SUPPLEMENTAL INSTRUCTION

PROJ.: Turnbull School
Music Room Addition
PROJ. No.: 1705
DATE: March 13, 2019
S.I. No. S.I. - 019

Existing Corridor Updates due to Fire Alarm and Door Operators

SCALE: 1 : 100
 ASK No. SI-019.01

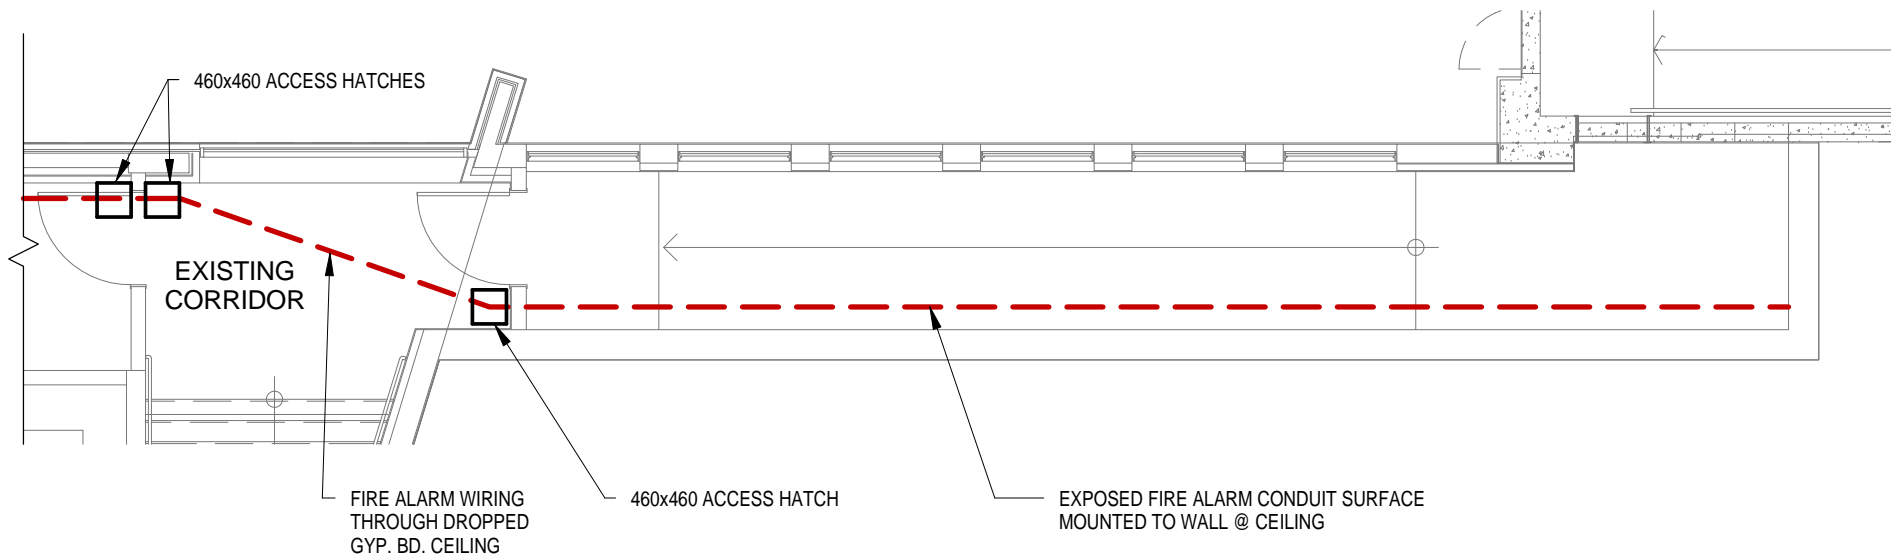
- .1 Refer to the attached Architectural Sketch SI-019.01 for the following:
 - .1 New fire alarm wiring through existing ceiling of existing corridor
 - .2 Three new 460x460 access hatches
 - .3 Cut existing block and repoint new block at location indicated to fish power to existing pull station
 - .4 New 41mm stud wall c/w new window sill to conceal conduit
